SERVICE BULLETIN

NUMBER: SB 500-34-005 rev B
MODEL: Eclipse EA500
SUBJECT: Pitot/Angle-of-Attack (AOA) System Upgrade

This service bulletin (SB) upgrades the Pitot/AOA probes and modifies the related tubing assembly, adding a water trap. The new Pitot/AOA probes and tubing assembly eliminate the possibility of icing in the Pitot/AOA system.

Figure 2. Pitot/AOA Assembly Removal (Sheet 1 of 2)

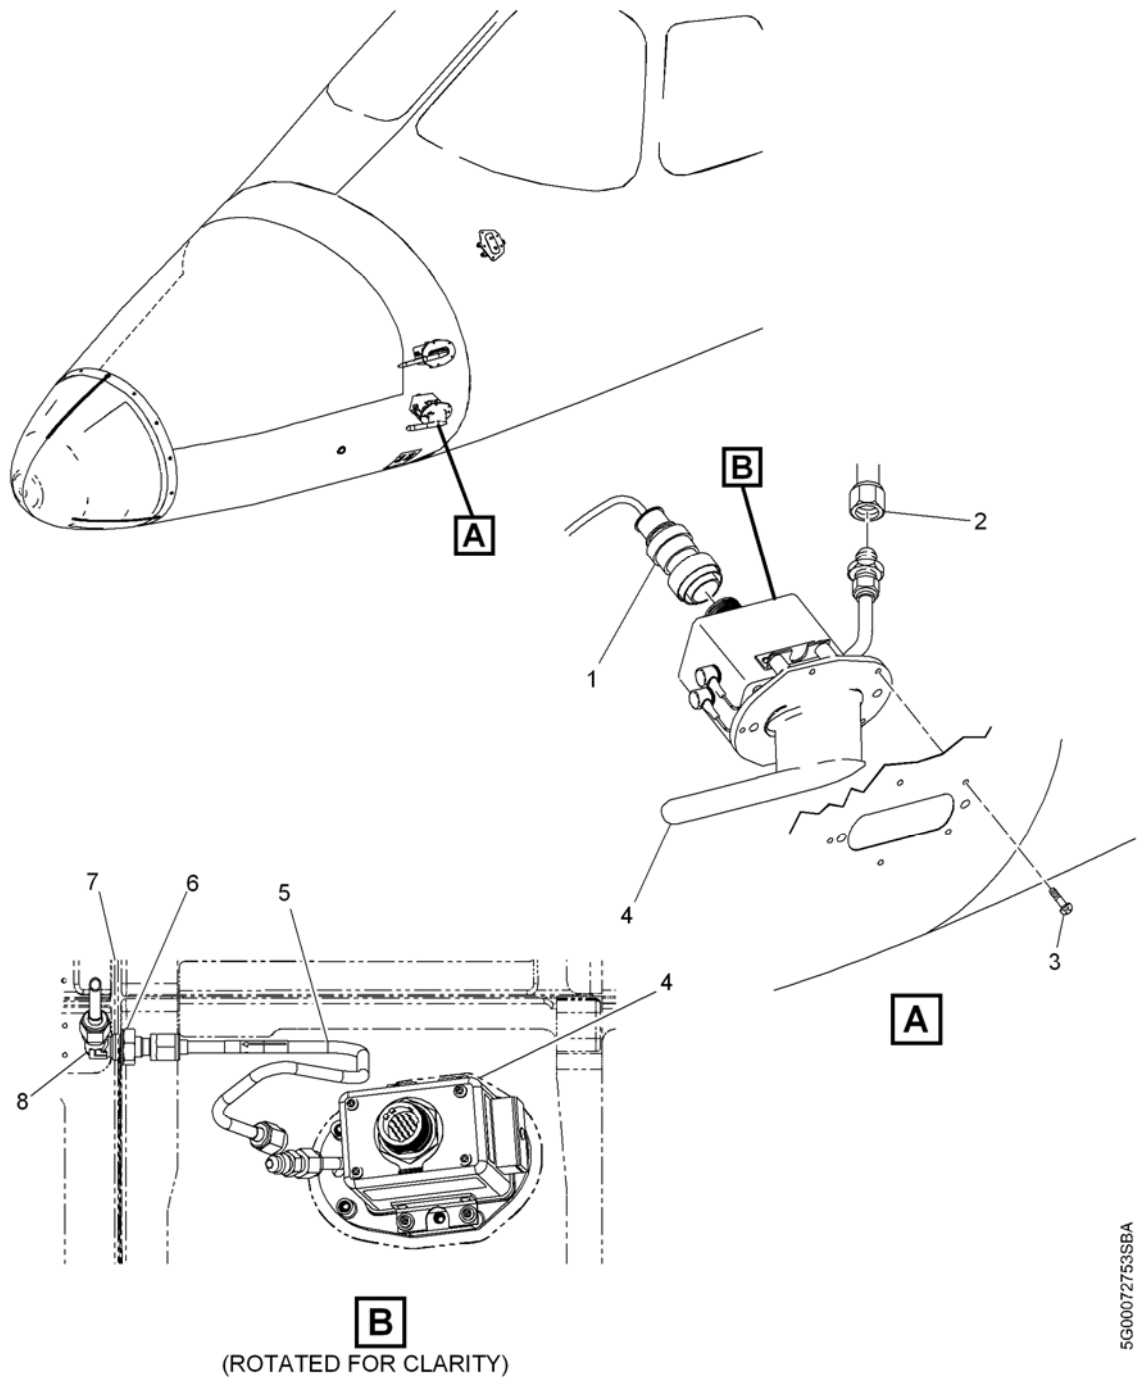
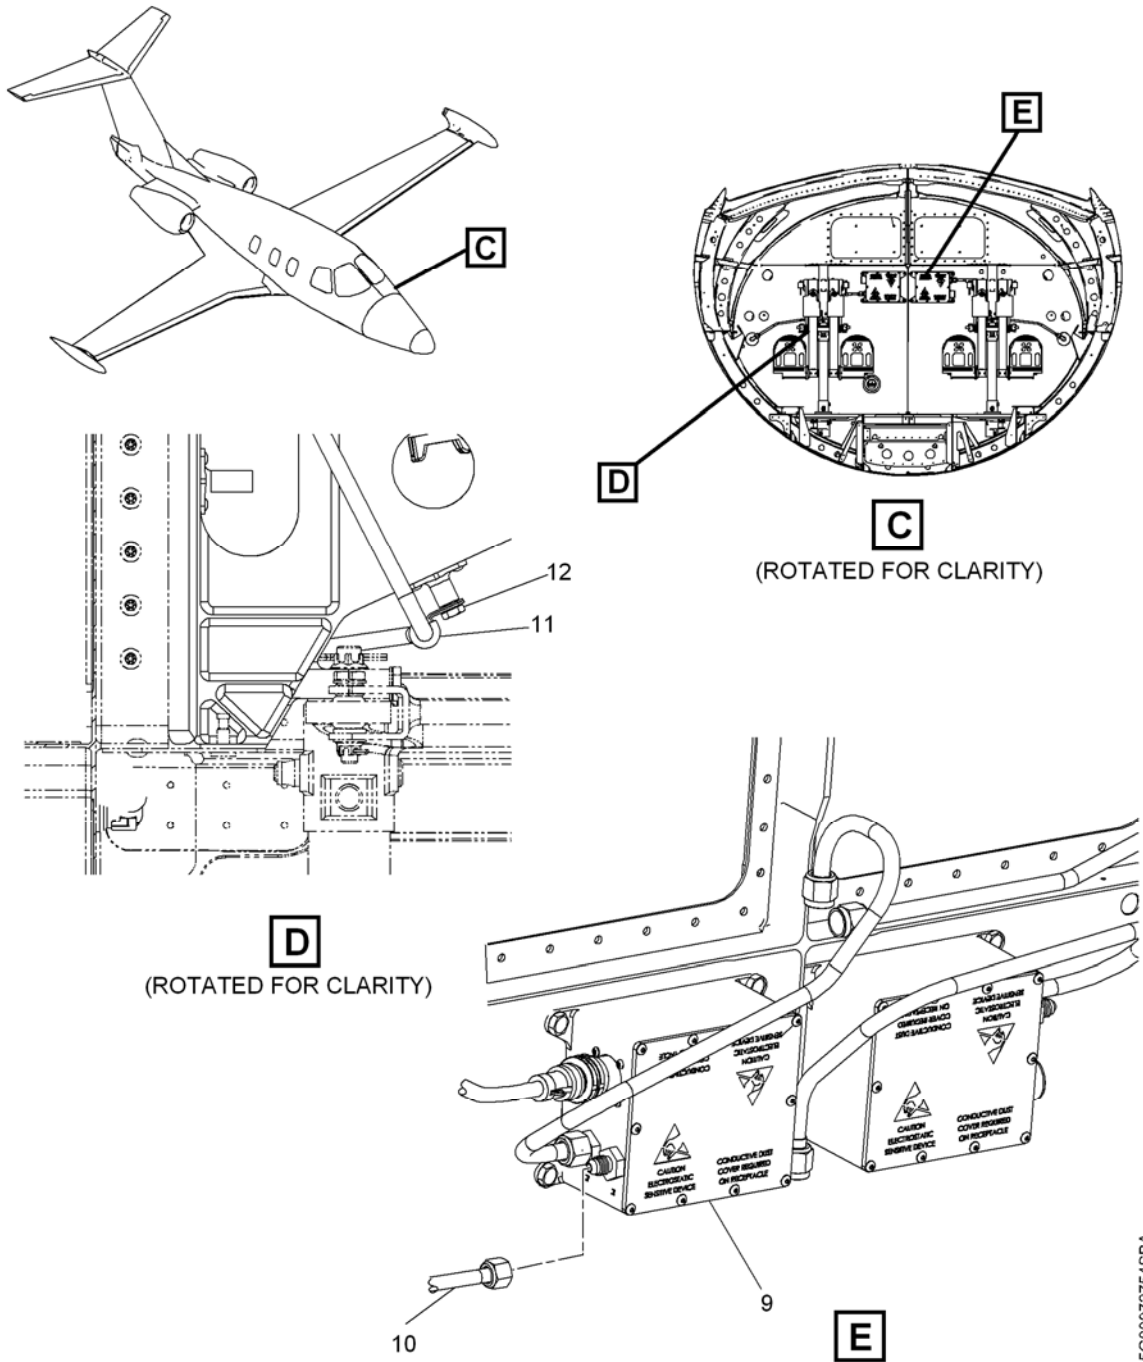
- (4) Remove left Pitot/AOA probe and tubing assembly as follows (Refer to Figure 2):
 - (a) Disconnect electrical connector (1) from Pitot/AOA probe P/N 100435-23 (4).
 - (b) Disconnect tubing assembly P/N 34-114375-1002 (5) from Pitot/AOA probe (4).

CAUTION: MAKE SURE TO USE CARE WHEN REMOVING TUBING FROM BULKHEAD ELBOW FITTING P/N AS1038D0404 (8). FAILURE TO USE CARE CAN RESULT IN DAMAGE TO FITTING.
 - (c) Disconnect and remove tubing assembly P/N 34-114375-1002 (5) from bulkhead elbow fitting P/N AS1038D0404 (8).
 - (d) Remove screw P/N NAS1801-3-8 (12), washer P/N NAS1149D0732J, and clamp P/N MS21919WDG4 (11) from rudder pedal mount.
 - (e) Disconnect tubing assembly P/N 34-114373-1002 (10) from Air Data Computer (ADC) 1 (9).

CAUTION: MAKE SURE TO USE CARE WHEN REMOVING TUBING FROM BULKHEAD ELBOW FITTING P/N AS1038D0404 (8). FAILURE TO USE CARE CAN RESULT IN DAMAGE TO FITTING.
 - (f) Disconnect and remove tubing assembly P/N 34-114373-1002 (10) from bulkhead elbow fitting P/N AS1038D0404 (8).

CAUTION: MAKE SURE TO USE CARE WHEN REMOVING BULKHEAD ELBOW FITTING P/N AS1038D0404 (8) AND BULKHEAD NUT FITTING P/N AS5178D04 (6). FAILURE TO USE CARE CAN RESULT IN DAMAGE TO FITTINGS.
 - (g) Remove bulkhead nut fitting P/N AS5178D04 (6) and bulkhead elbow fitting P/N AS1038D0404 (8) from forward bulkhead (7). Keep bulkhead nut and elbow fittings.
 - (h) Remove screws P/N NAS8702-2 (3) and Pitot/AOA probe P/N 100435-23 (4).
- (5) Repeat step 4 to remove right Pitot/AOA probe and tubing assembly. Refer to drawings 34-121975-1001 and 34-121983-1001 for correct P/N removal.

Figure 3. Pitot/AOA Assembly Installation (Sheet 1 of 2)

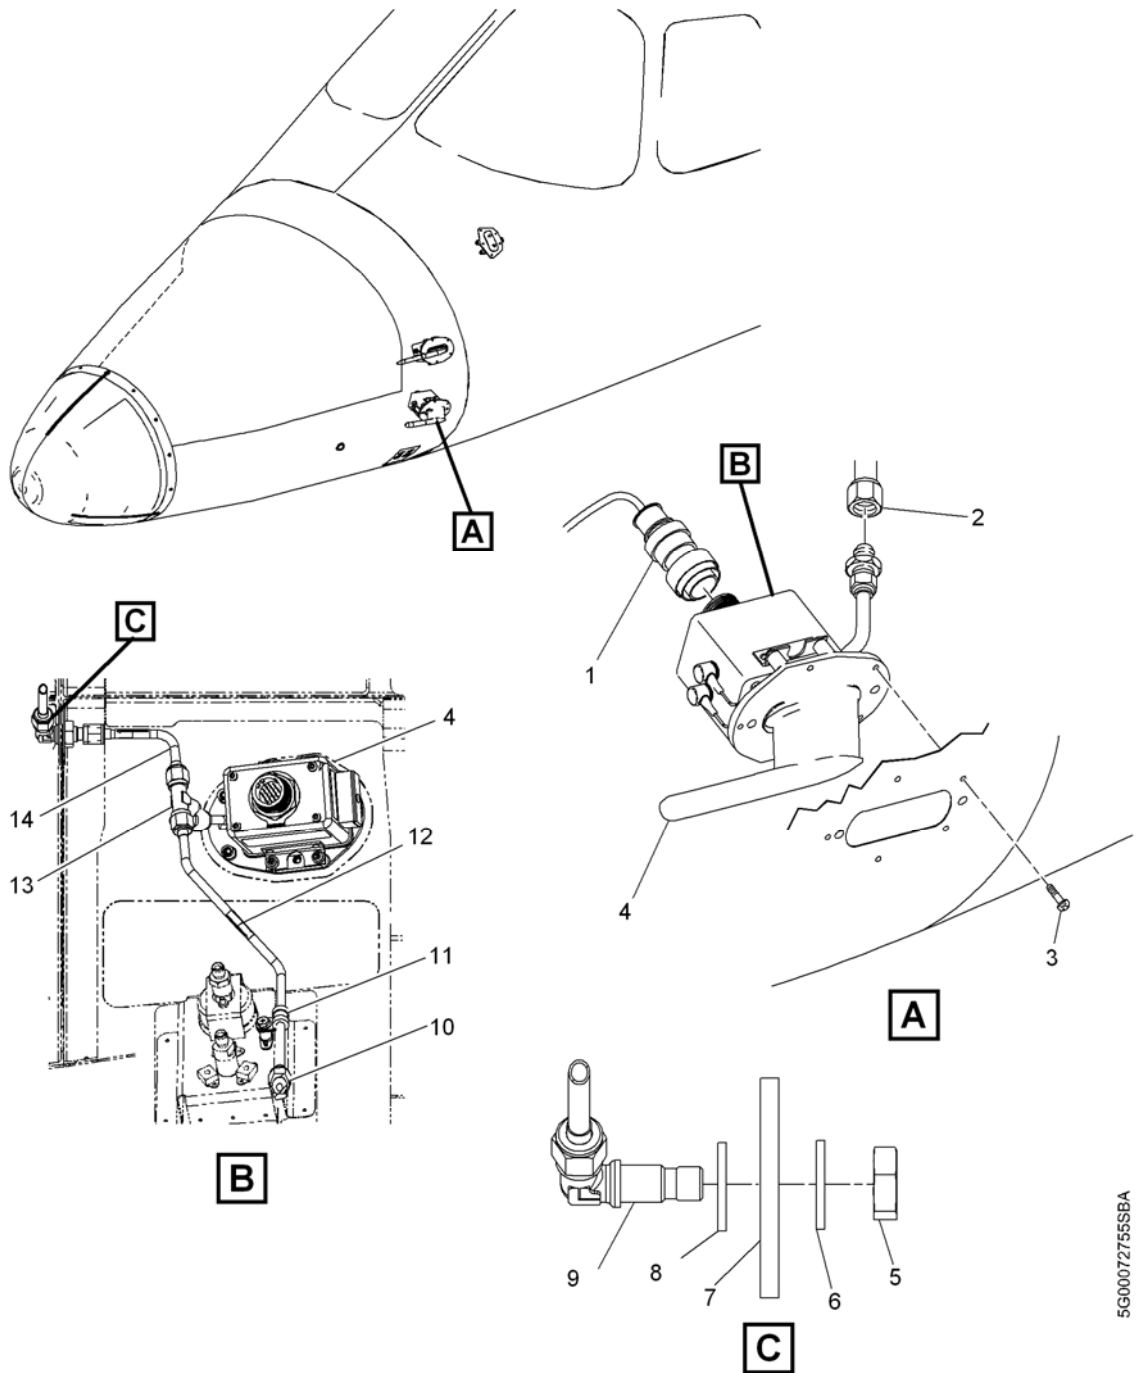
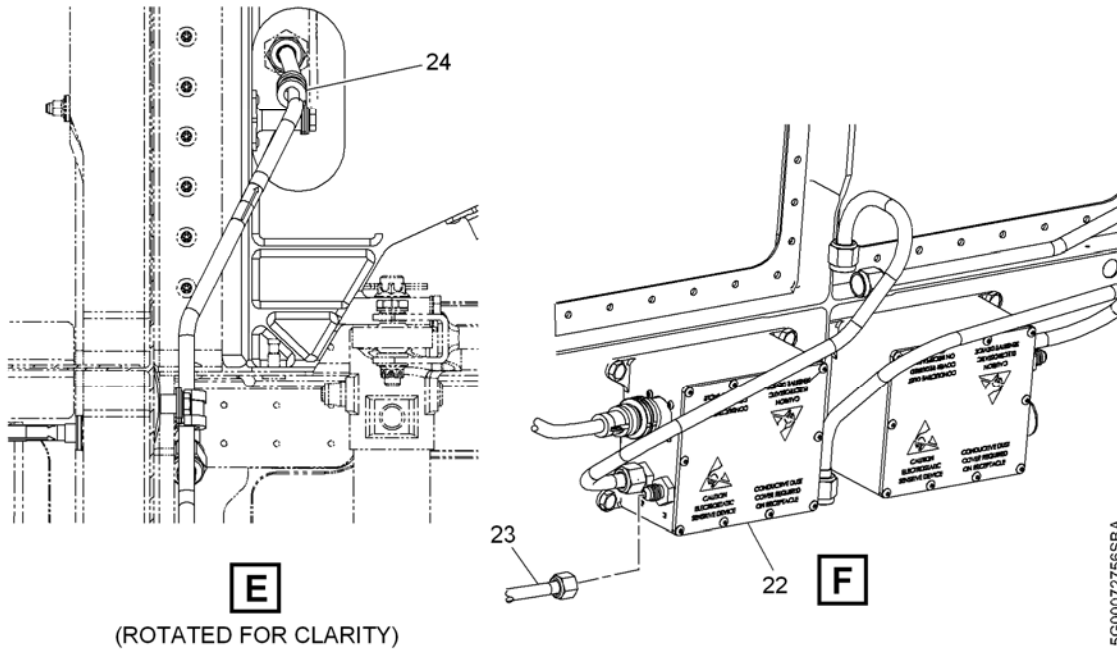
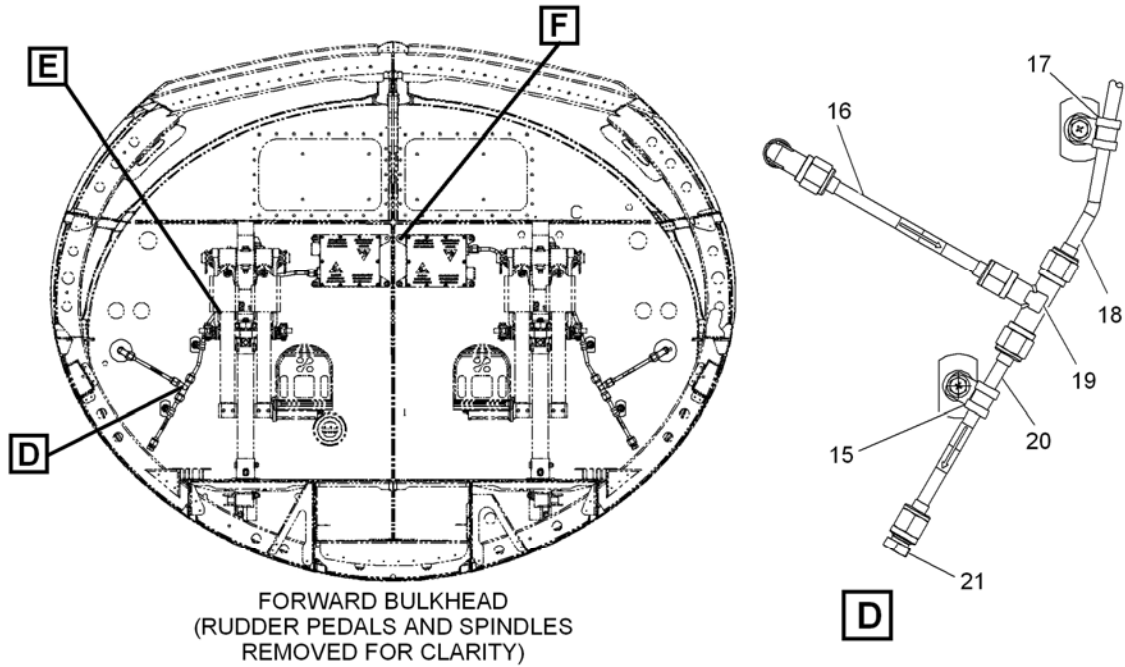
- (6) Install left Pitot/AOA probe and tubing assembly as follows (Refer to Figure 3):
- (a) Loosely install bulkhead nut fitting P/N AS5178D04 (5), two nylon washers P/N MS51859-21 (6, 8), and bulkhead elbow fitting P/N AS1038D0404 (9).

Note: Make sure arrow displayed on tubing P/N 34-121967-1002 (14) points towards the ADC and the arrow displayed on tubing P/N 34-121969-1001 (12) points toward the drain.

- (b) Loosely connect tubing P/N 34-121967-1002 (14) and tubing P/N 34-121969-1001 (12) to tee P/N AS1035D040404 (13).
 - (c) Connect and secure tubing P/N 34-121967-1002 (14) to bulkhead elbow fitting P/N AS1038D0404 (9).

- (d) Install Pitot/AOA probe P/N 100435-39 (4) with screws P/N NAS3702-2 (3).
 - (e) Do electrical bonding of Pitot/AOA probe (4) to aircraft. Refer to AMM 20-03-00. Resistance must be 2.5 milliohms or less.

- (f) Connect electrical connector (1) to Pitot/AOA probe P/N 100435-39 (4).
 - (g) Connect tee P/N AS1035D040404 (13) to Pitot/AOA probe P/N 100435-39 (4).

- (h) Torque the following connections. Refer to EAC P1020.
 - 1. Tubing P/N 34-121967-1002 (14) and tubing P/N 34-121969-1001 (12) to tee P/N AS1035D040404 (13).

- 2. Tee P/N AS1035D040404 (13) to Pitot/AOA probe P/N 100435-39 (4).
 - (i) Install standoff P/N CB3001AA3-6P for clamp MS21919WDG4 (11). Refer to sheet 2, section H-H of drawing 34-121975-1001.

- (j) Install clamp P/N MS21919WDG4 (11). Refer to sheet 2, section H-H of drawing 34-121975-1001.
 - (k) Secure tubing P/N 34-121969-1001 (12) to clamp P/N MS21919WDG4 (11).

- (l) Install plug fitting P/N AS516D04 (10) into tubing P/N 34-121969-1001 (12).
 - (m) Loosely connect tubing P/N 34-121979-1001 (16) to bulkhead elbow fitting P/N AS13038D0404 (11).

- (n) Loosely connect tubing P/N 34-114373-1003 (18) and tubing P/N 34-121979-1001 (20) to tee P/N AS1035D040404.
 - (o) Loosely connect tubing P/N 34-114373-1003 (18) to ADC 1 (15).

- (p) Torque the following connections. Refer to EAC P1020.
 - 1. Tubing P/N 34-121979-1001 (20) and tubing P/N 34-114373-1003 (18) to tee P/N AS1035D040404 (19).

- 2. Tubing P/N 34-114373-1003 (18) to ADC 1.
 - 3. Bulkhead elbow fitting P/N AS13038D0404 (9) and bulkhead nut fitting P/N AS5178D04 (5).
 - (q) Install standoffs P/N CB3001AA3-6P for clamps MS21919WDG4 (15, 17). Refer to sheet 2, section A-A and section B-B of drawing 34-121975-1001.
